# *I-65 TO US-31W CONNECTOR WARREN COUNTY, KENTUCKY*

Item Number 3-16.00  
VE Study Number 201108

Kentucky Transportation Cabinet  
Frankfort, Kentucky

**Final Report**

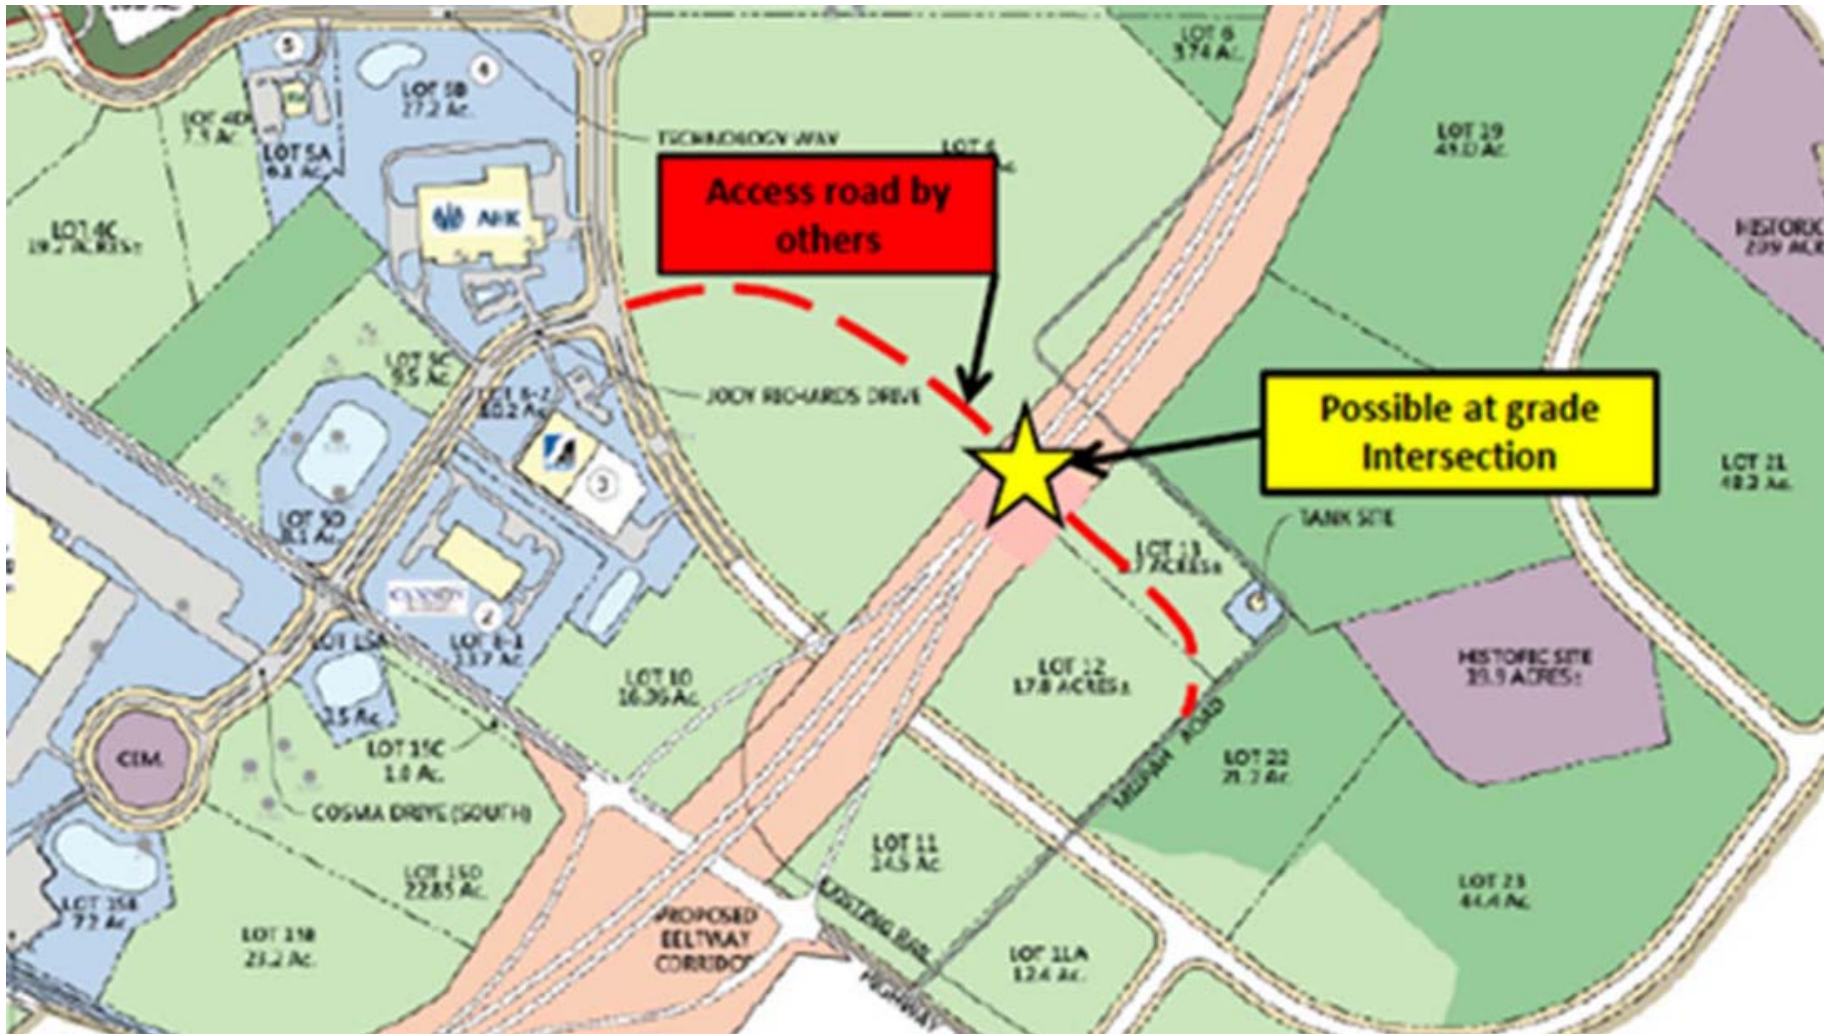
The original design specifies a grade separation for Commonwealth Boulevard at a location shown on a conceptual master plan for the Transpark development. The original design also calls for Mizpah Road to be realigned parallel to the connector serving as a frontage road.

The VE Team recommends utilizing an at-grade intersection for Commonwealth Boulevard by shifting the intersection north toward US-31W. This would change the access control from full control to partial control and eliminate the need for a bridge. It would also eliminate the need for the relocated Mizpah Road which was being proposed as a frontage road. See the illustrations below for a better understanding of the concept.

The VE Team believes this recommendation should be considered by the Project Team since the change will still serve the Transpark development while not requiring the construction of a bridge and Mizpah Road relocation. The VE Team roughly looked at Station 215+00 as an option given the profile grade on the connector closely matches the existing ground elevation. The change from full access control to partial access control will still help preserve the future traffic operation of the corridor especially given the traffic volume drop-off on the connector between US68/KY80 and US-31W.

Accident Modification Factors for Lane Width on Rural Two-Lane Highways.

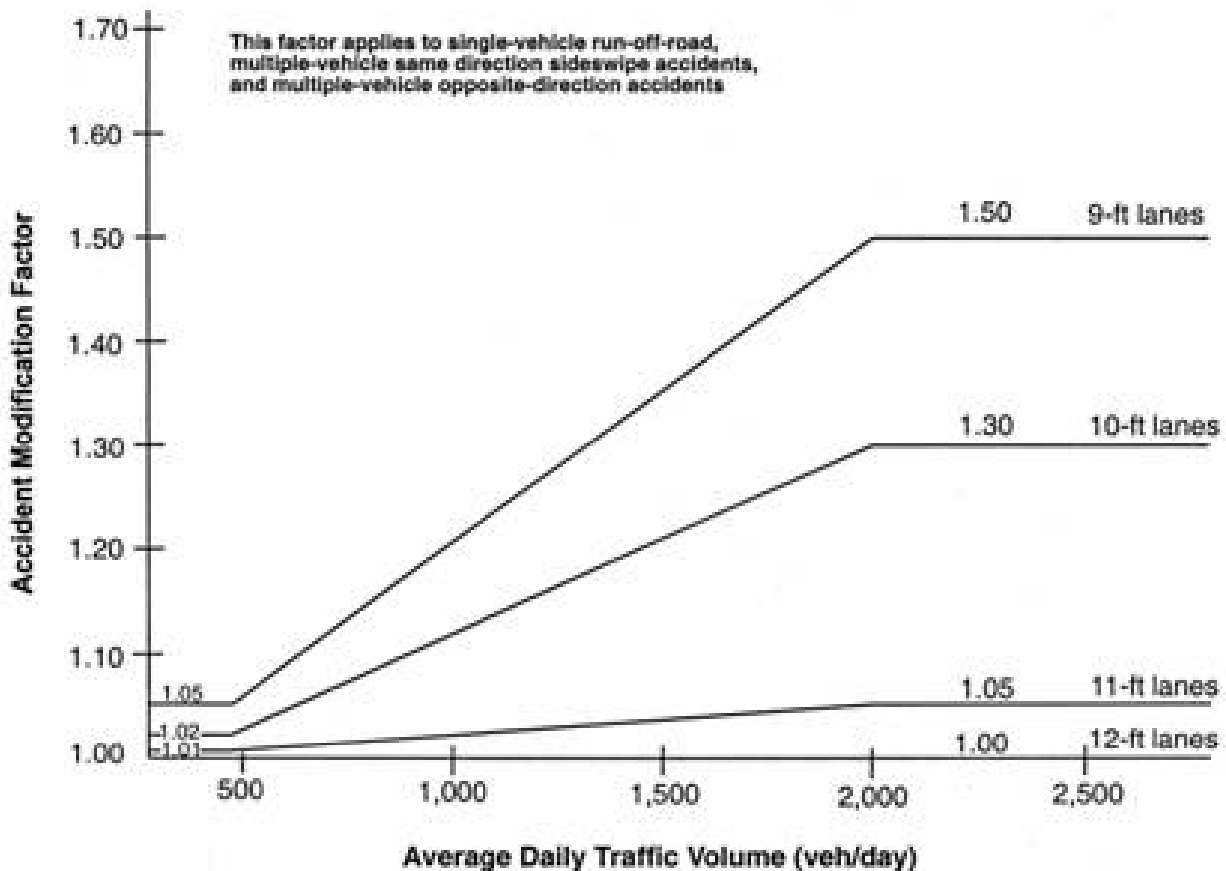
Reduce the driving lane width to 11 ft. in lieu of 12 ft. lanes.

Utilize an 11 ft. lane in lieu of a 12 ft. lane for the connector. Studies have shown that there is not an appreciable change in operation or safety by reducing the lane width from 12 ft. to 11 ft. This would be more applicable if the Project Team (or KYTC Administration) decides the connector will not be part of I-66 and the possible of having an initial 2-lane section.

The figure below shows accident modification factors for variations in lane width on rural two-lane highways. Note that there is little difference between 11 and 12 ft. lanes.

**MOT Plan Sheet Phase 1**

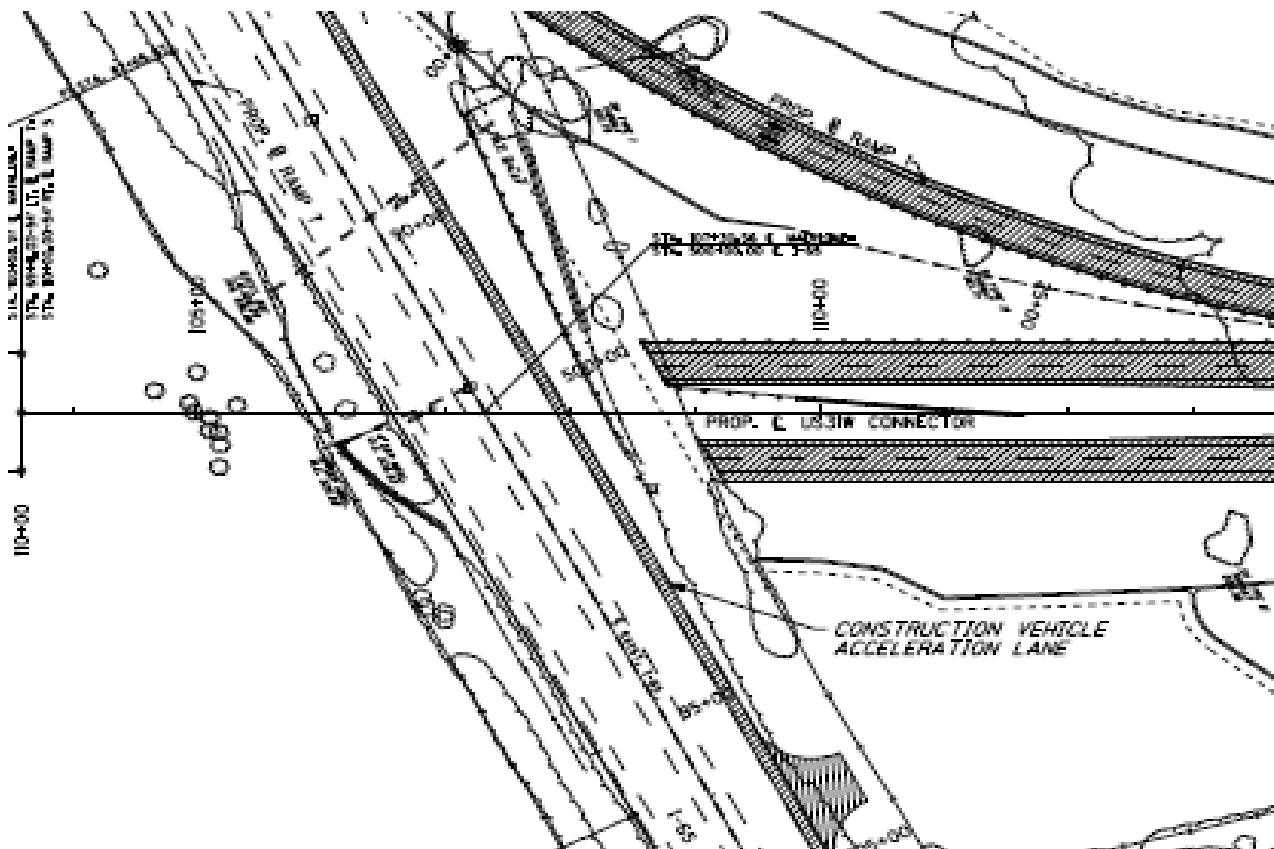
The current phasing plans allow for a “T” intersection directly onto I-65. The VE Team anticipates that this “T” intersection will impact traffic on I-65. In our opinion, impacts to I-65 should be minimized. The VE Team recommends deceleration and acceleration lanes for access along I-65 in order to minimize impacts to the flow of traffic. The VE Team also recommends contract requirements pushing construction traffic entering I-65 away from I-65 (i.e., to adjacent interchanges) if deceleration or acceleration lanes are not provided.

Connector over I-65 Phase 1

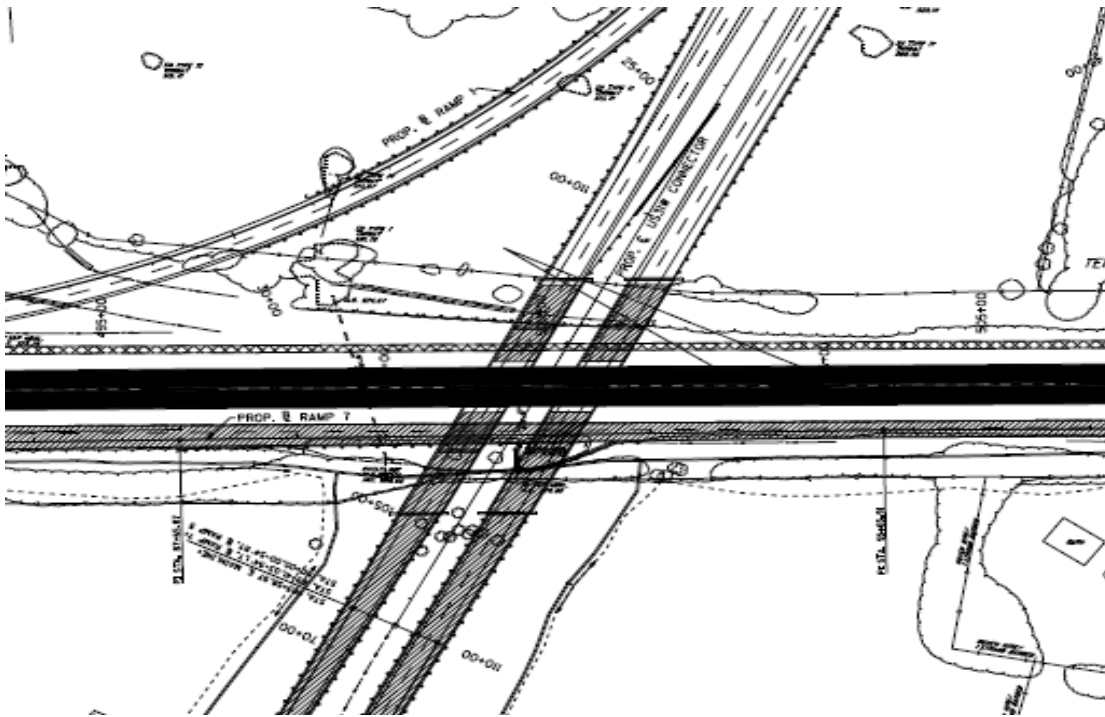
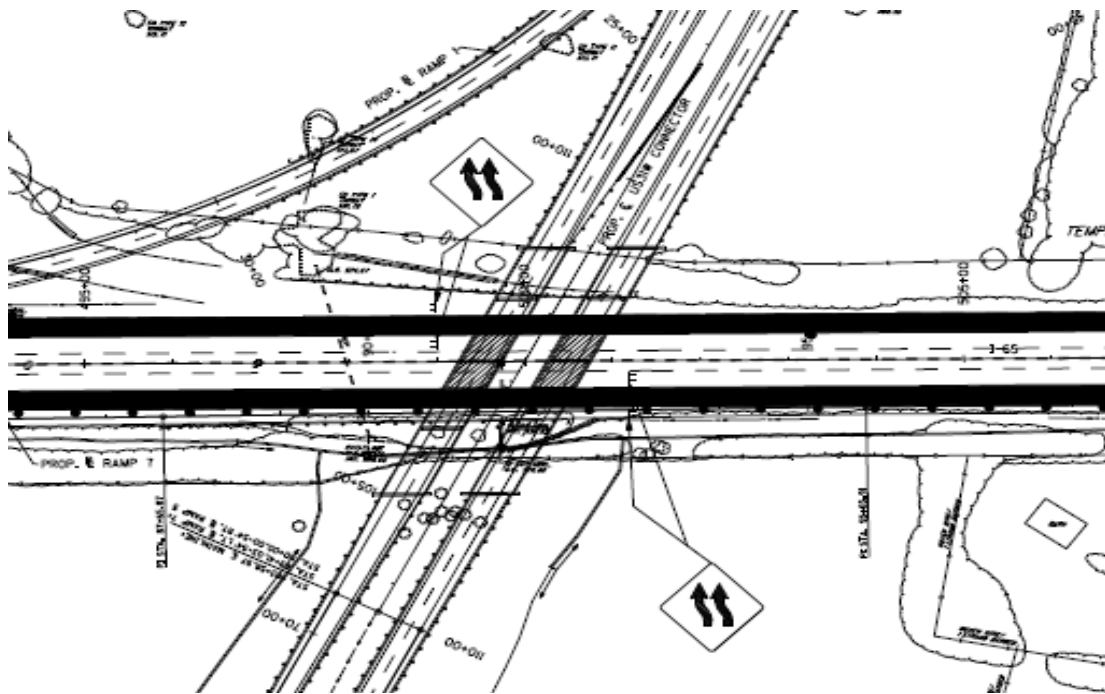
The current phasing plans specify construction of the Connector over I-65 bridges in later phases and appear to promote discontinuity in the construction schedule for these bridges. The VE Team recommends phasing that dictates the construction and completion of these bridges (or at least one of them) in the first phase. The completed bridge can serve as a crossing for construction traffic across I-65. This may alleviate impacts to I-65 traffic. Significant material deliveries are required on this project. The embankment importation quantities are significant and concrete delivery is required. Exit points with deceleration for the construction traffic can be installed along both the westbound or eastbound directions. All I-65 entry can be directed to existing interchanges west and east of the project until the new ramps are constructed to a useable condition with acceleration lanes for construction traffic. The VE Team also recommends continuity in construction schedules in order to maximize the efficiency during construction and therefore reduce construction costs.
